Re: Indian Point Unit No. 2
Docket No. 50-247
NL 00-148

**SUBJECT: Indian Point 2 License Amendment Request - Revisions to the
Technical Specifications**

LICENSE AMENDMENT REQUEST

**LICENSE AMENDMENT REQUEST
TECHNICAL SPECIFICATION PAGES IN
STRIKEOUT/SHADOW FORMAT**

E. CONTROL ROOM AIR FILTRATION SYSTEM

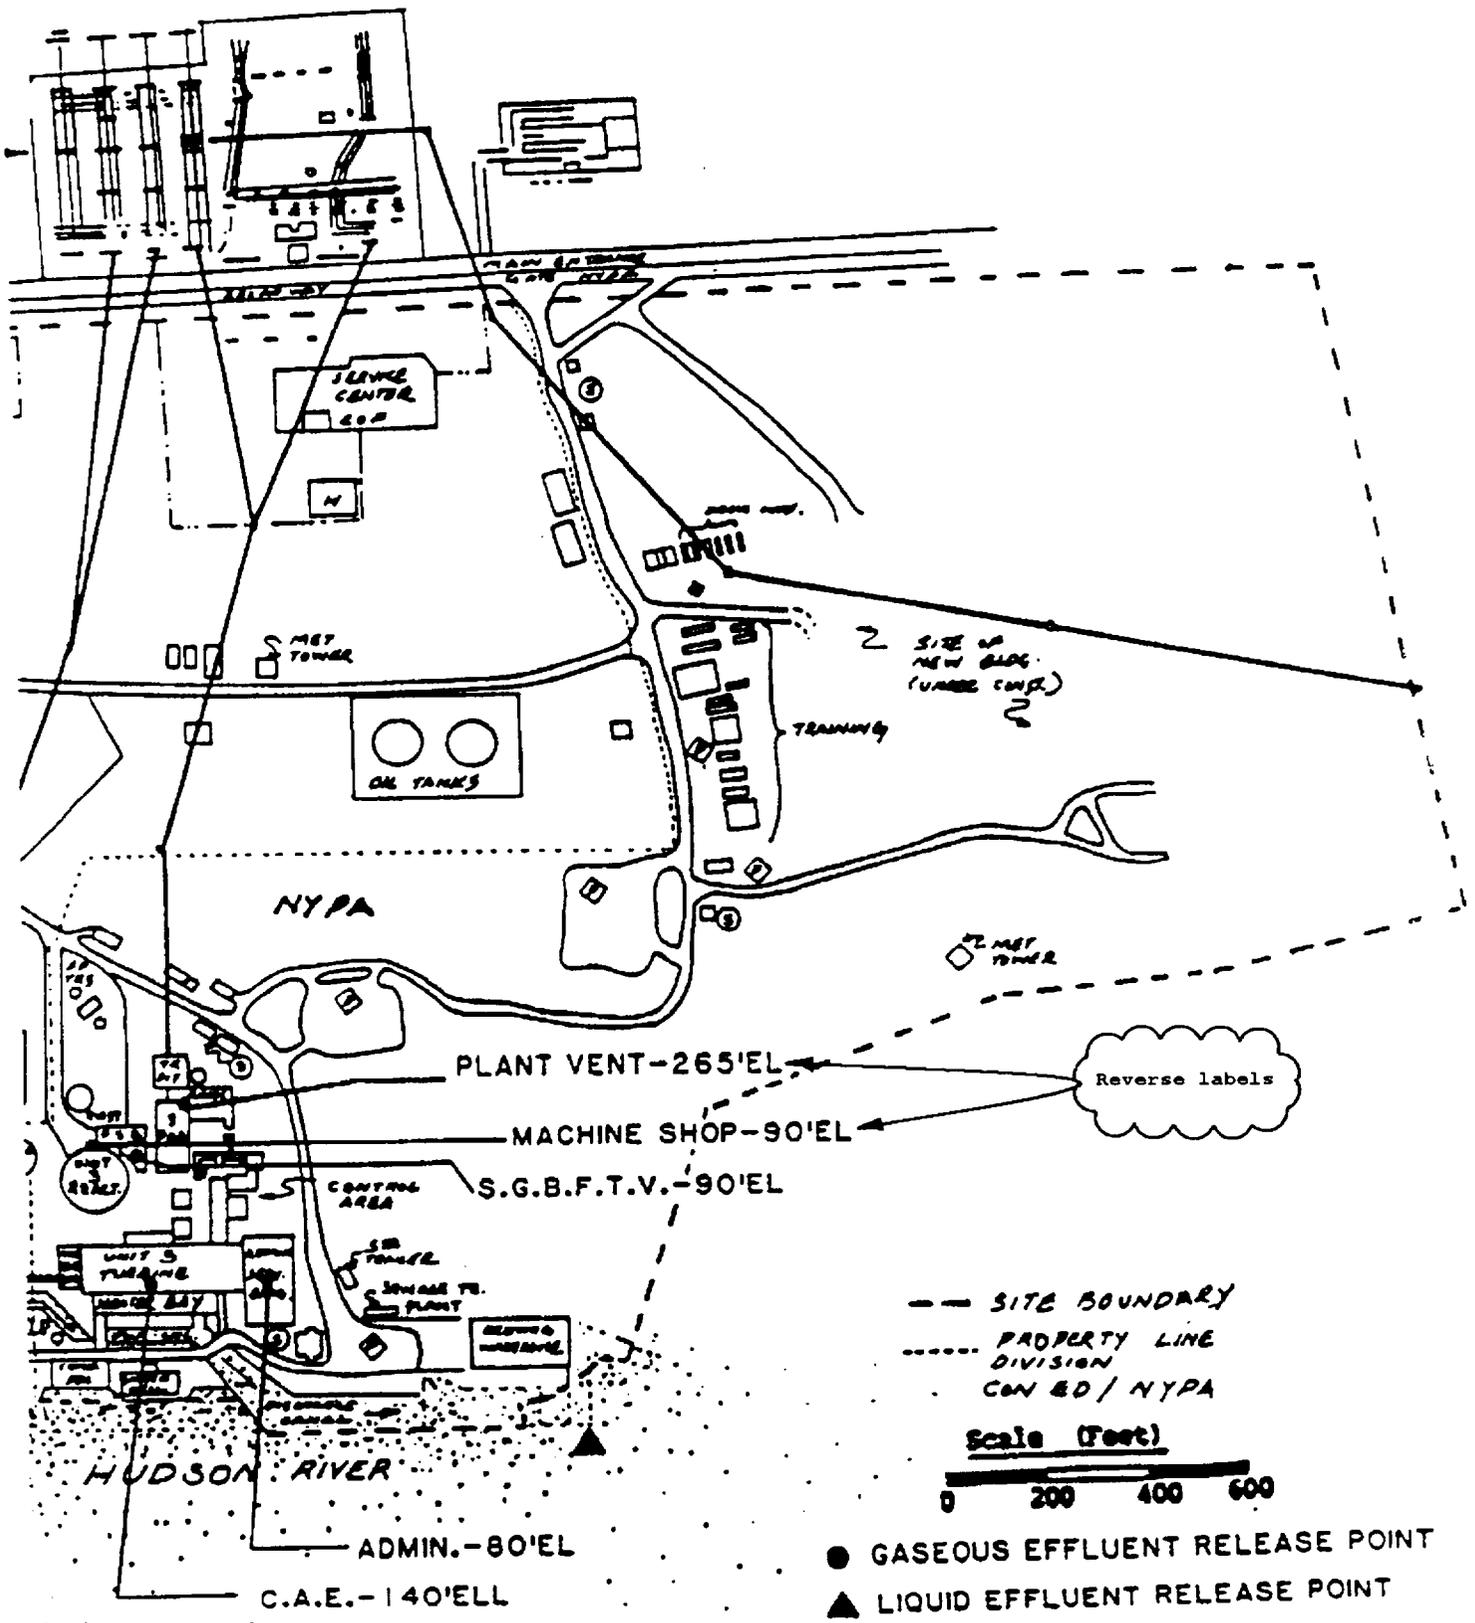
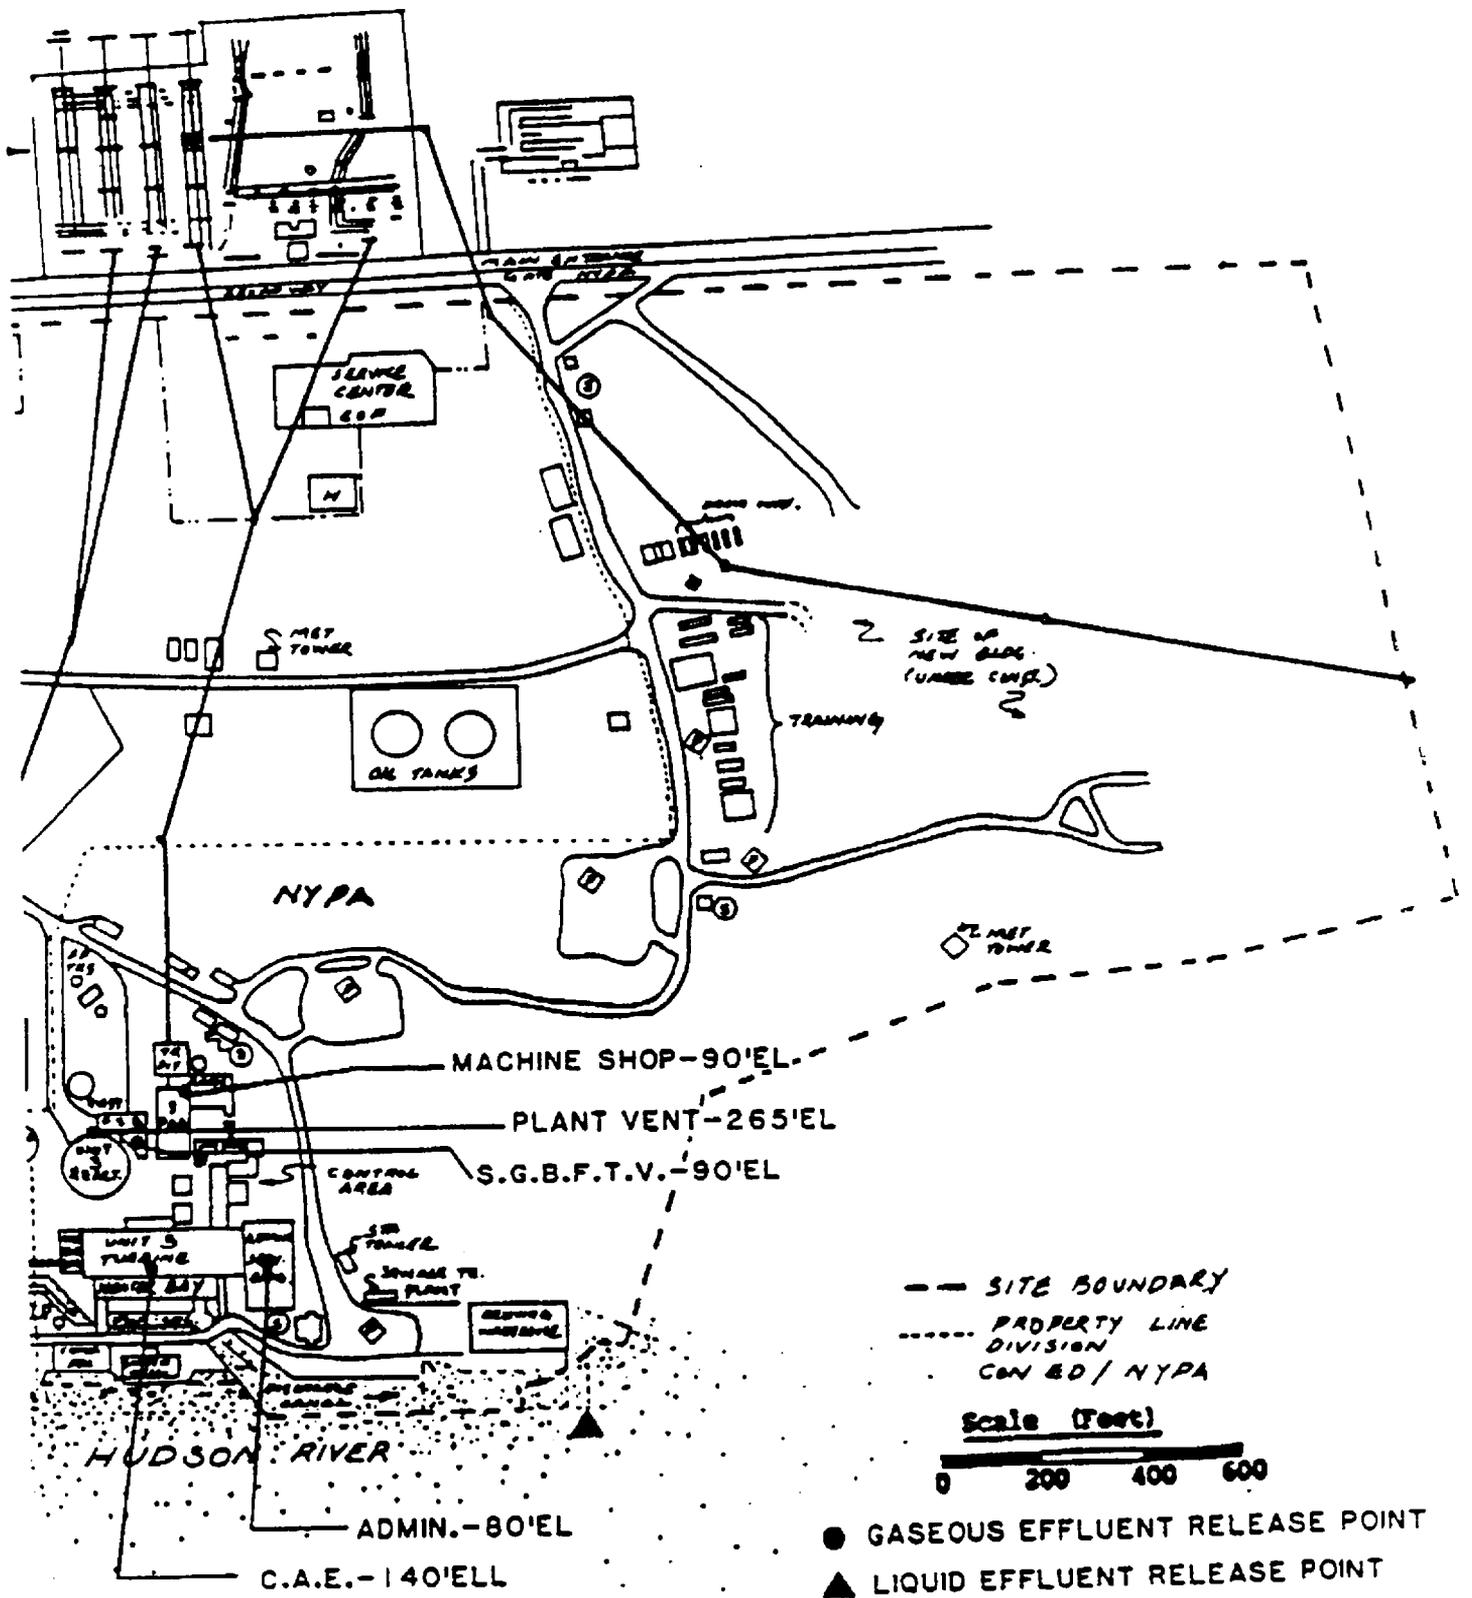
This change proposes revisions to TS 4.5.E, "Control Room Air Filtration System," to remove an incorrect system description and provide consistent test values for system flow rate and filter efficiency. These changes were previously discussed in Reference 8. Specifically, these changes involve the following corrections.

1. TS 4.5.E.2.b is being deleted in its entirety. This test was added to the TS in error as part of TS Amendment No. 77. The specified test for bypass flow to the facility vent through the system diverting valves applies to ventilation systems that filter air being released to the atmosphere and does not apply to the control room air filtration system which filters air being discharged to the control room.

2. TS 4.5.E.4.c is being revised to include the system flow rate at which this specification applies. A system flow rate 2000 cfm $\pm 10\%$ will be specified. This will remove any ambiguity from the specification and provide consistency with the other specifications for the control room air filtration system.

3. TS 4.5.E.5 is being revised to require a filter bank efficiency of greater than or equal to 99.95% of DOP versus the current value of 99%. The value of 99.95% reflects the current test value and is conservative to the design basis value of 99%.

1. TS 4.5.E.2.b requires testing of "the total bypass flow of the system to the facility vent, including leakage through the system diverting valves." This requirement was added in error as part of Amendment No. 77 (Reference 3). Prior to Amendment No. 77, the requirements for the control room air filtration system were not included in the IP2 TSs.

2. The system flow rate of 2000 cfm \pm 10% is being added to the requirements of TS 4.5.E.4.c which requires verification that the control room air filtration system maintains the control room at positive pressure relative to the adjacent areas. This is the same value that is already included in TSs 4.5.E.2.a, 4.5.E.2.b, 4.5.E.2.c, 4.5.E.4.a, 4.5.E.5, and 4.5.E.6. This proposed change adds specific clarification to this TS and does not affect the system configuration or operation. This change was previously discussed in Reference 8.

3. The HEPA filter bank efficiency of the control room air filtration system in TS 4.5.E.5 is being revised to require a removal value of greater than or equal to 99.95% of the DOP. The proposed value is more conservative than currently provided in the Technical Specifications and is conservative to the value of 99% that is used in the corresponding radiological dose calculations. This value is consistent with Regulatory Position C.5.c of Regulatory Guide 1.52, Revision 2. The use of this more conservative value was previously discussed in Reference 8.

- a. verifying a system flow rate, at ambient conditions, of 2000 cfm \pm 10% during system operation when tested in accordance with ANSI N510-1975.
 - b. ~~verifying that, with the system operating at ambient conditions and at a flow rate of 2000 CFM \pm 10% and exhausting through the HEPA filters and charcoal adsorbers, the total bypass flow of the system to the facility vent, including leakage through the system diverting valves, is less than or equal to 1% when the system is tested by admitting cold DOP at the system intake. DELETED~~

- c. verifying that the system maintains the control room at positive pressure relative to the adjacent areas during ~~system operation~~ the pressurization mode of operation at a makeup flow rate of 2000 cfm $\pm 10\%$.

5. After each complete or partial replacement of an HEPA filter bank, by verifying that the HEPA filter banks remove greater than or equal to 99.95% of the DOP when they are tested in-place in accordance with ANSI N510-1975 while operating the system at ambient conditions and at a flow rate of 2000 cfm $\pm 10\%$.
